UNITED STATES PATENT AND TRADEMARK OFFICE

APPLICATION NO.	FILING DATE	FIRST NAMED INVENTOR	ATTORNEY DOCKET NO.	CONFIRMATION NO.
10/809,106	03/26/2004	Peter D. Lee	58632US004	6665

Office Action Summary	Application No. 10/809,106	Applicant(s) LEE ET AL.	
	Examiner Teena Mitchell	Art Unit 3743

DETAILED ACTION

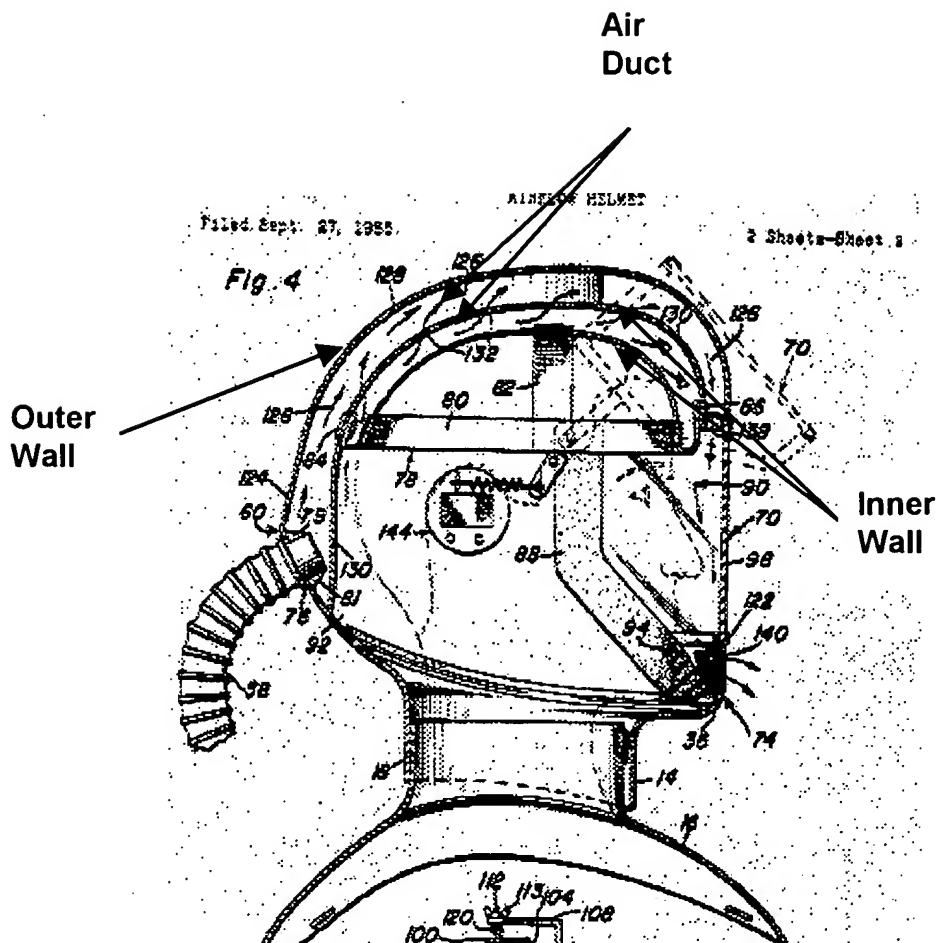
With respect to claim 6, Depping discloses wherein the visor forms at least part of a side wall of the hood (70; inasmuch as the visor is part of the air chamber it inherently forms at least part of a side wall of the hood; Figs. 1, 2, 4).

With respect to claim 10, Depping discloses wherein the air chamber comprises an outer wall of the hood and an inner wall secured to the outer wall around a perimeter edge of the hood to define the air duct there between (see illustration of Fig. 4 below).

With respect to claim 12, Depping discloses wherein the outer wall and inner wall are shape stable (Fig. 4).

With respect to claim 18, Depping discloses wherein the outer wall is a top wall of the hood (Fig. 4).

With respect to claim 19, Depping discloses wherein the top wall and inner wall of the air chamber are permanently secured together (Fig. 4).

With respect to claim 26, Depping discloses wherein the top wall and inner wall of the air chamber are secured together around the perimeter of the hood and are spaced apart inwardly of the perimeter (Fig. 4).
